Tree removal – Lyonpark Road Bridge

drawing title:
ADDITIONAL TREES TO BE REMOVED

SECTION 4.55(1A) MODIFICATION APPLICATION - SSD 8903 Stage 1 of Ivanhoe Estate, Macquarie Park

Company Name:	Department of Planning, Industry and Environment
Attn:	Lucinda Craig / Lara Fusco
Date:	8 December 2021
Re:	Request for additional information
Project Name:	Ivanhoe Stage 1 SSD DA - MOD 3

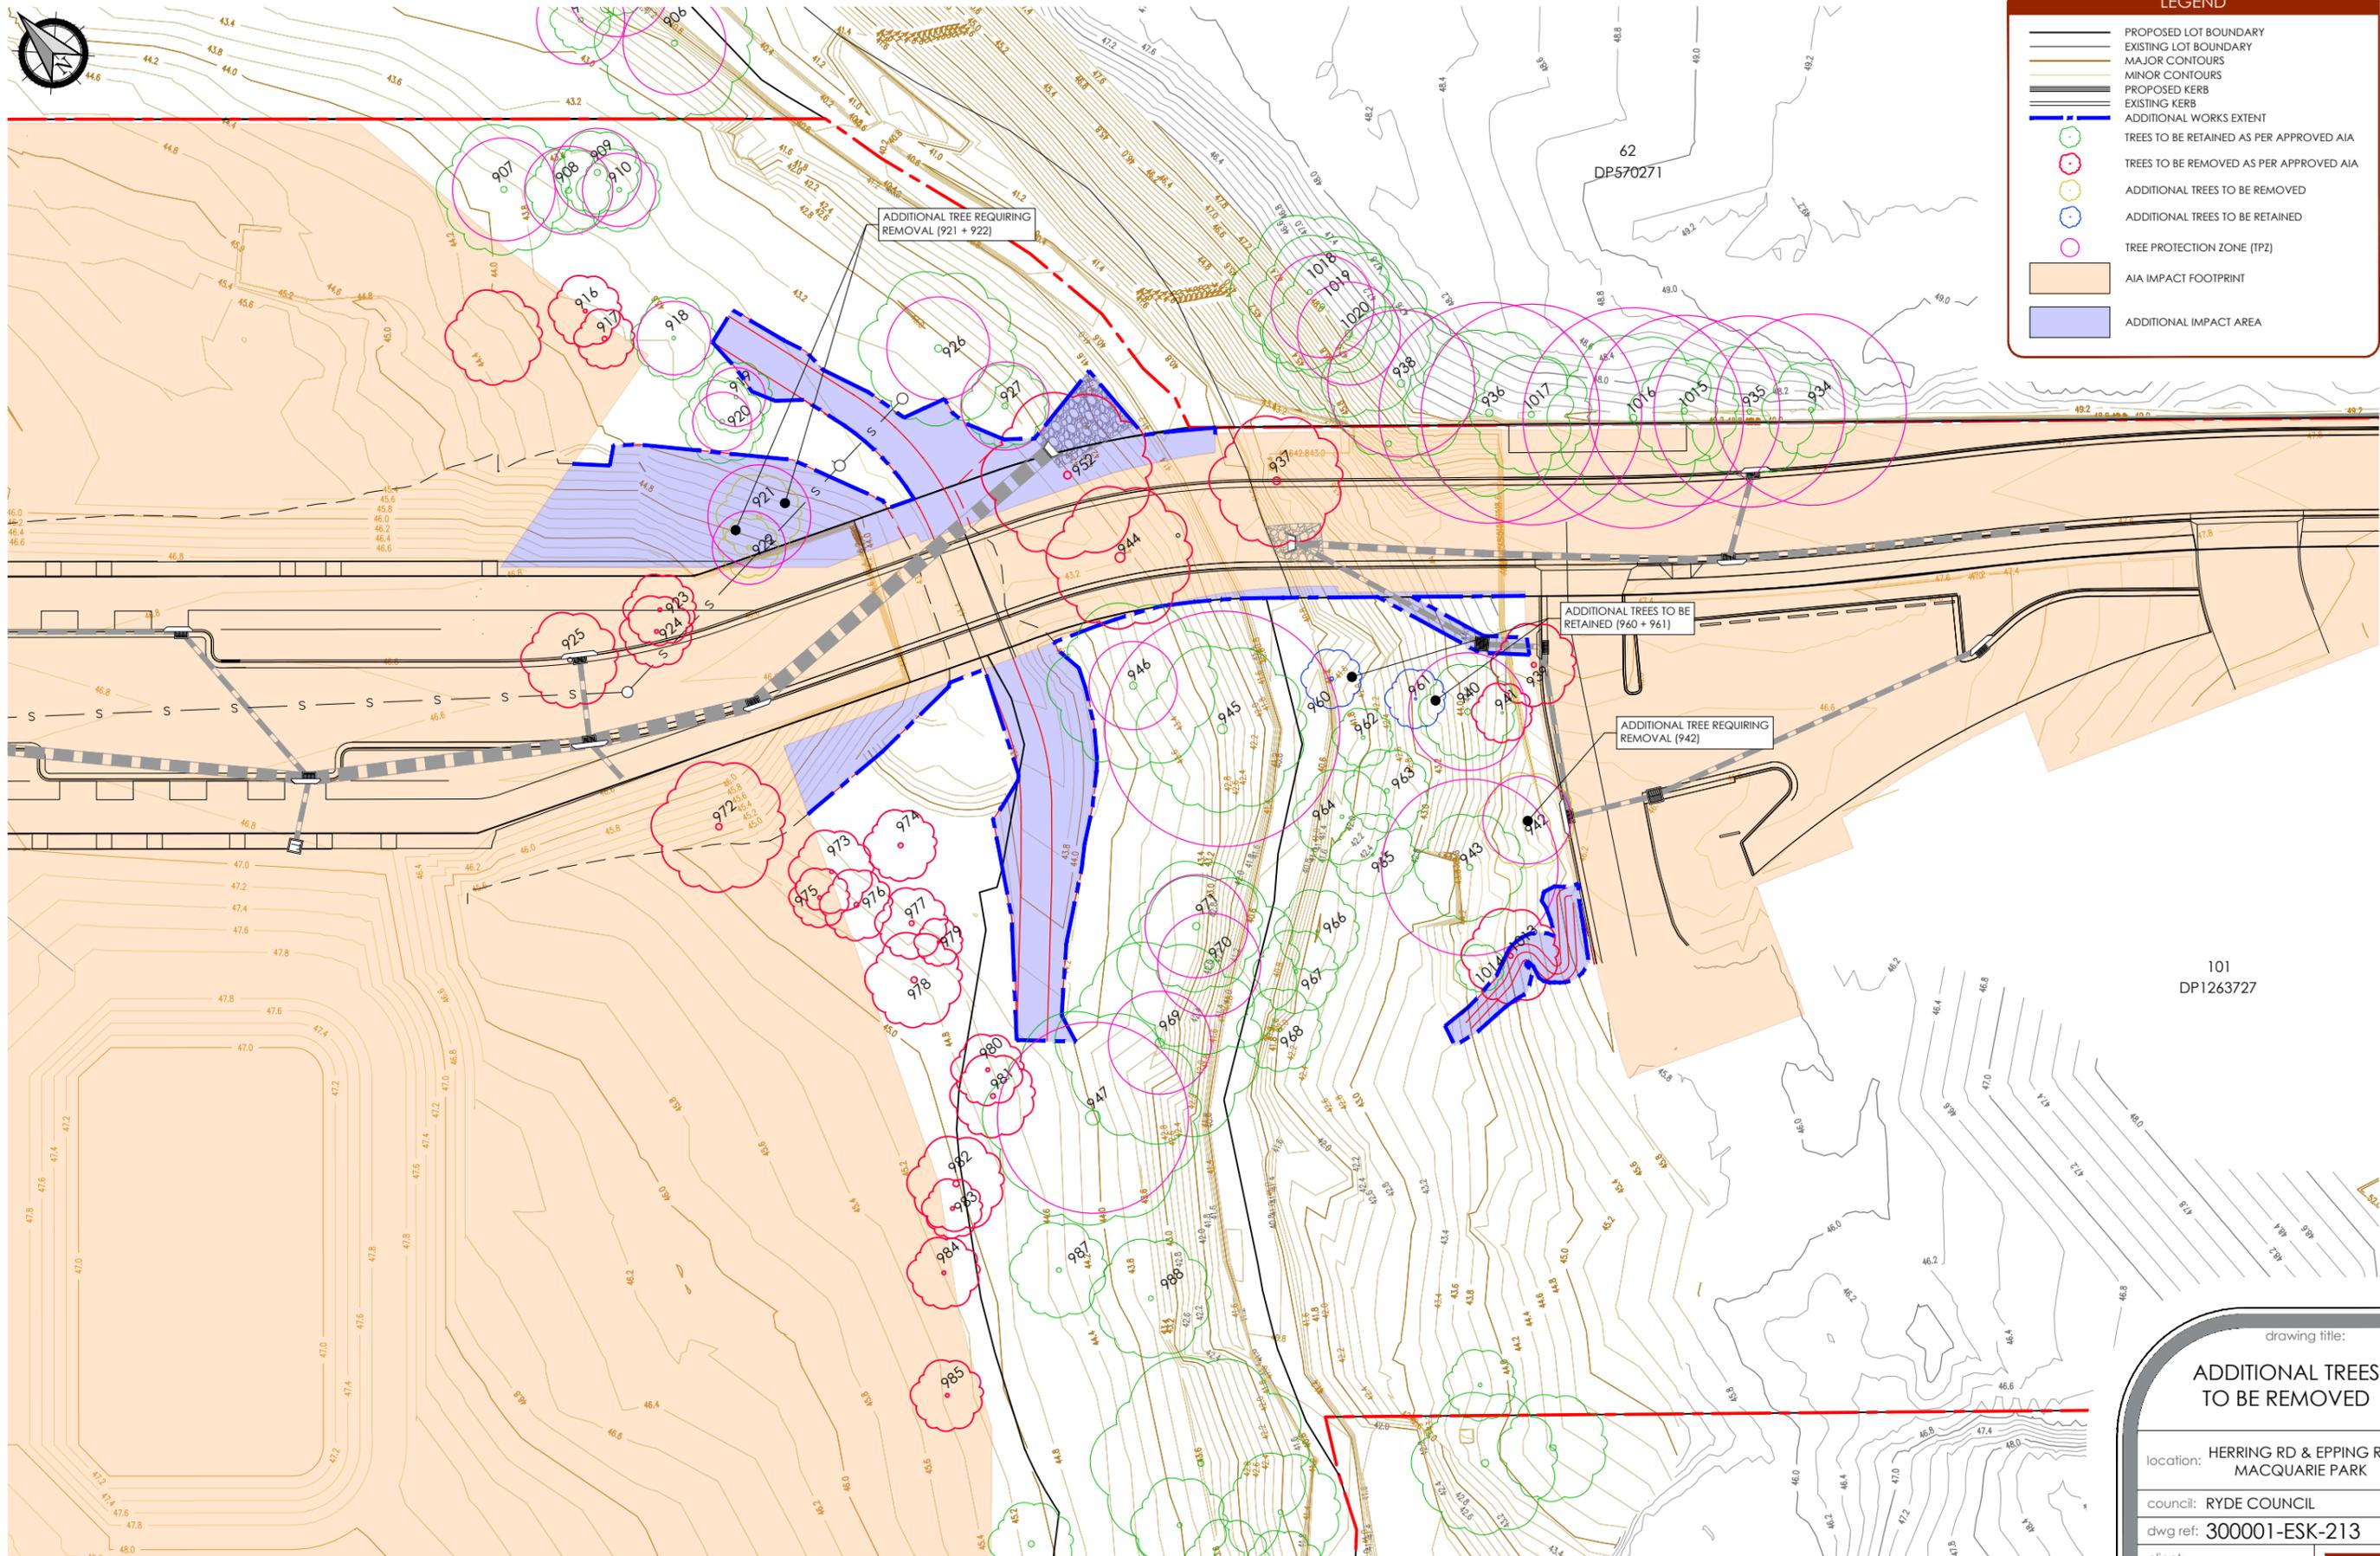
The Stage 1 DA (SSDA 8903) subsequently included Condition B103 to widen the northern verge of the bridge joining to Lyonpark Road. Design drawings prepared by ADW Johnson show that two trees (921 and 922 in the Arboricultural Impact Assessment) proposed for retention require removal. These are shown on the attached drawing (dwg ref 300001-ESK-213).

A third tree (942) will also need to be removed due to construction of a stormwater outlet.

The above would increase tree removal from 853 to 856. ADW Johnson has however identified that two trees (960 and 961) previously approved for removal no longer require removal, meaning there is a net change of -1 trees. Given the Arboricultural Impact Assessment was based on Concept drawings, it is understandable that minor changes such as this are possible.

drawing title:
ADDITIONAL TREES TO BE REMOVED

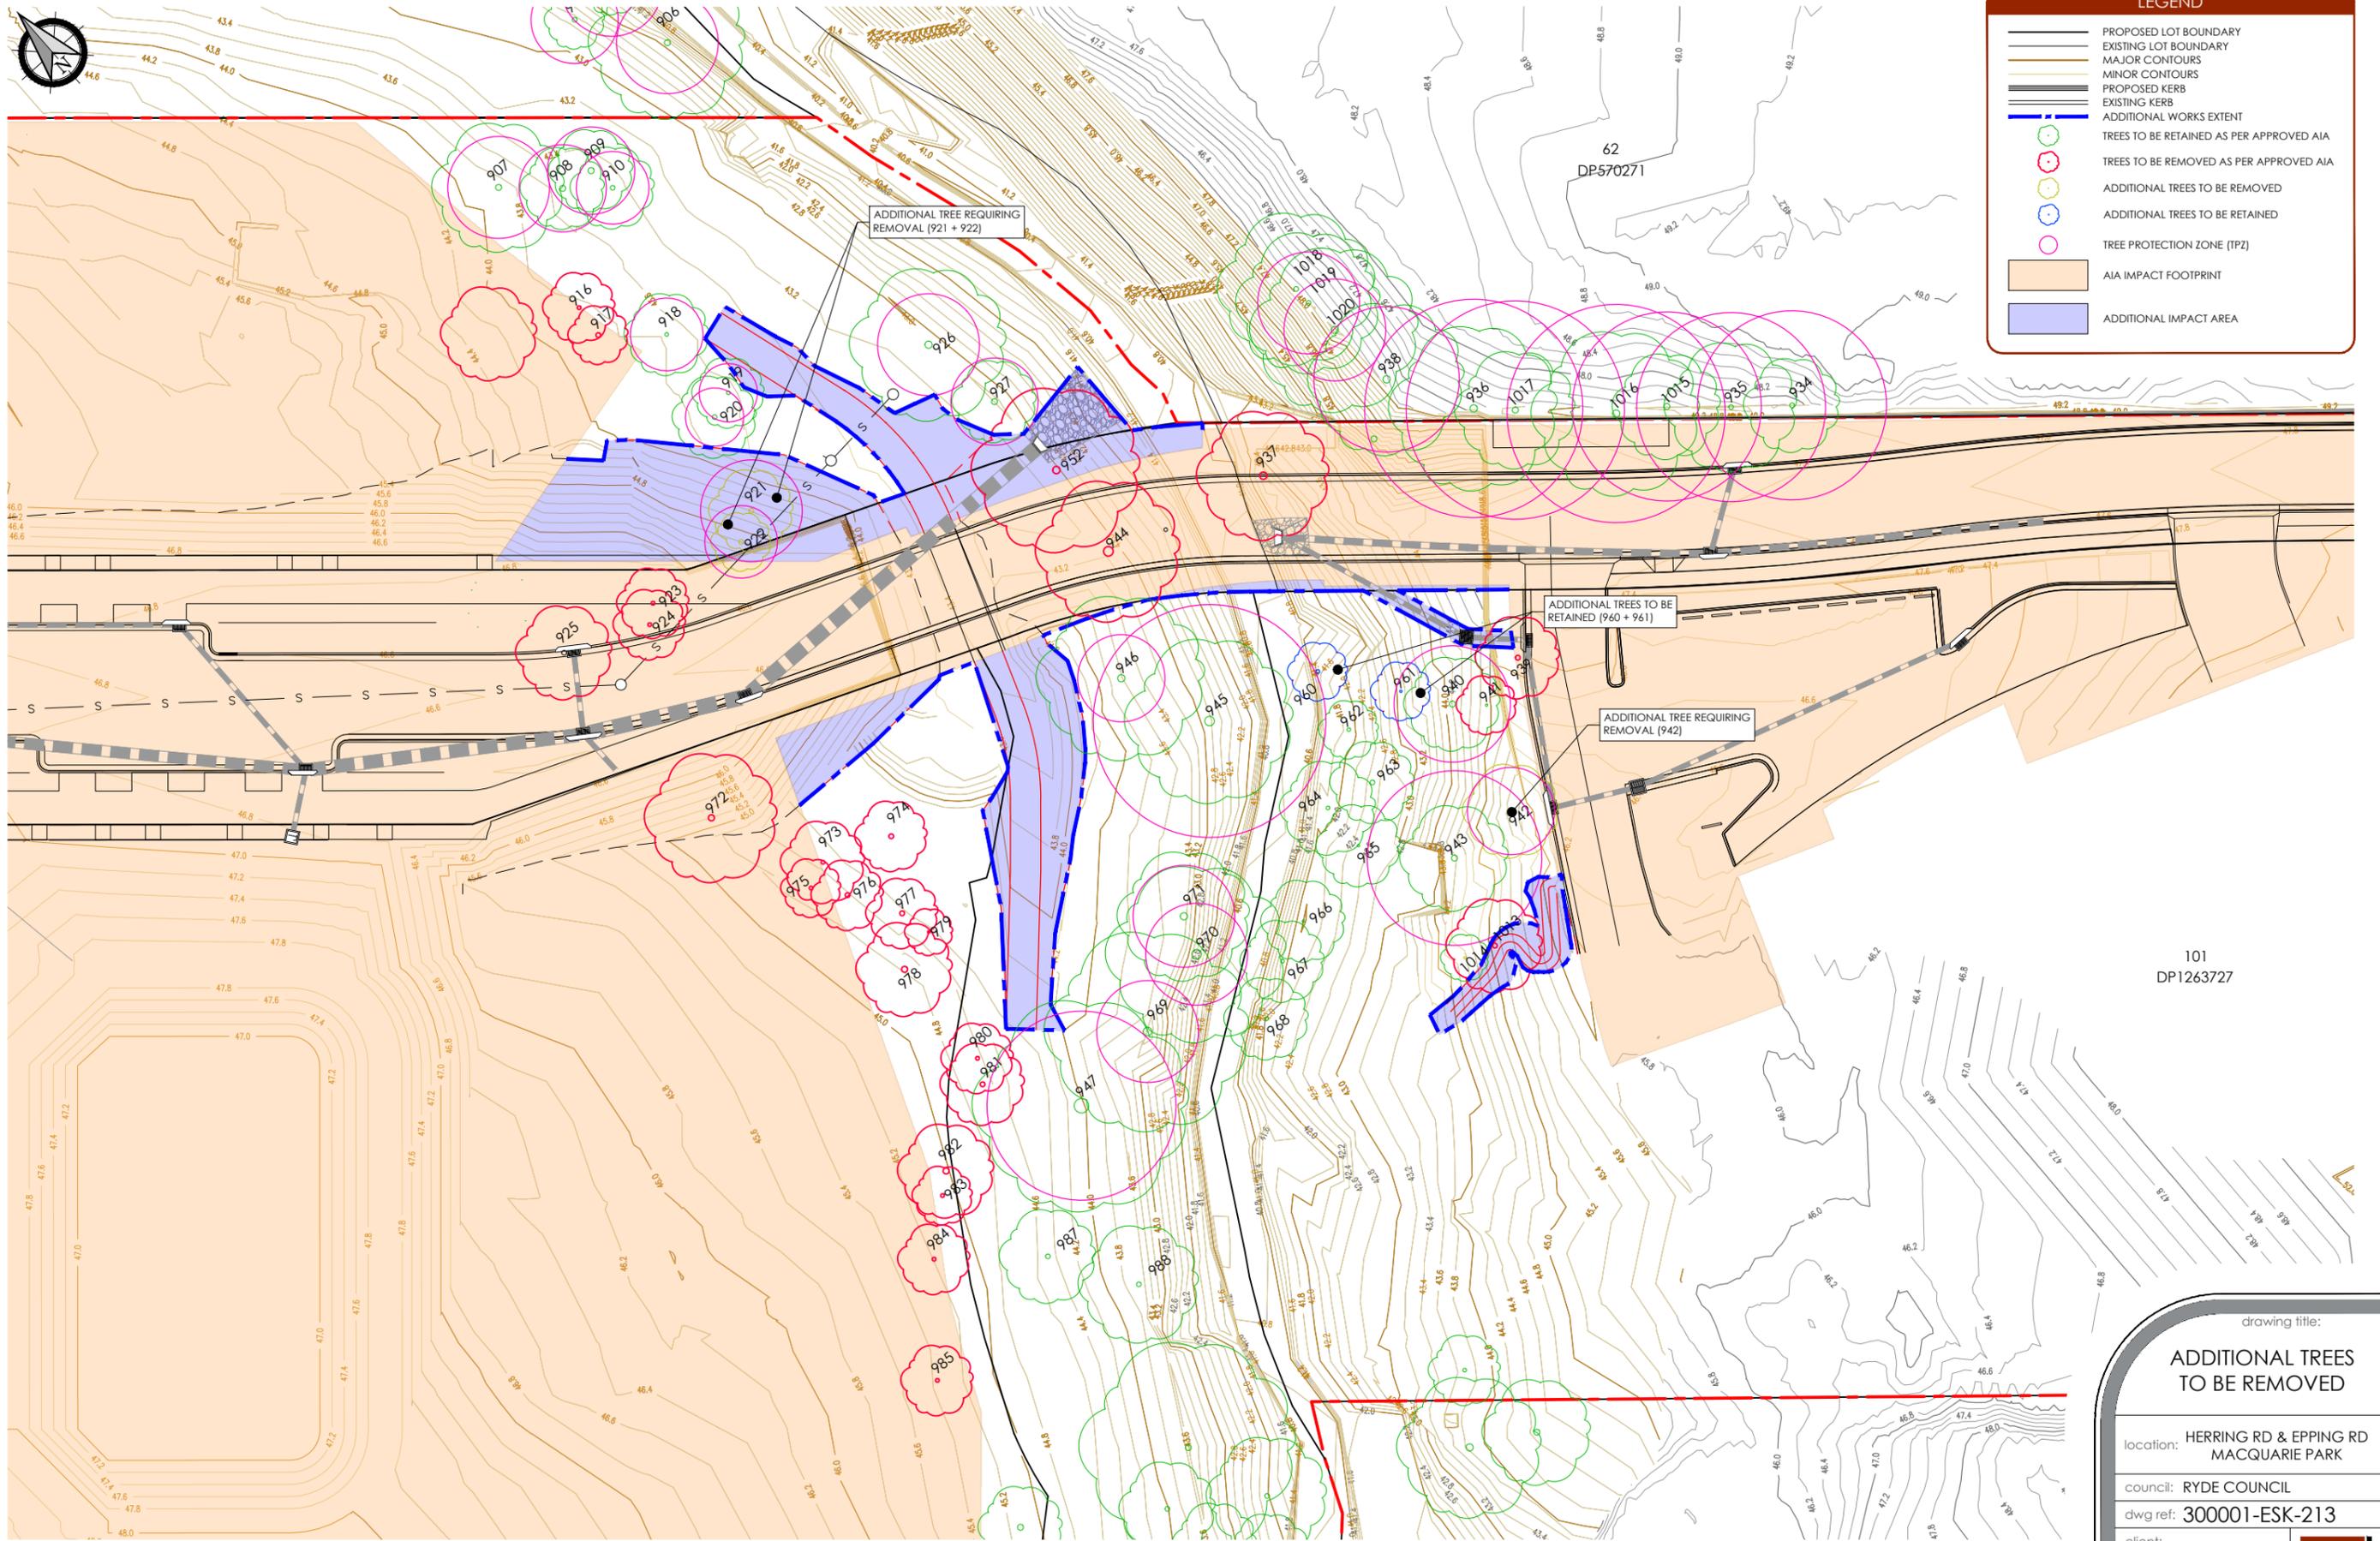
The Stage 1 DA (SSDA 8903) subsequently included Condition B103 to widen the northern verge of the bridge joining to Lyonpark Road. Design drawings prepared by ADW Johnson show that two trees (921 and 922 in the Arboricultural Impact Assessment) proposed for retention require removal. These are shown on the attached drawing (dwg ref 300001-ESK-213).

A third tree (942) will also need to be removed due to construction of a stormwater outlet.

The above would increase tree removal from 853 to 856. ADW Johnson has however identified that two trees (960 and 961) previously approved for removal no longer require removal, meaning there is a net change of -1 trees. Given the Arboricultural Impact Assessment was based on Concept drawings, it is understandable that minor changes such as this are possible.
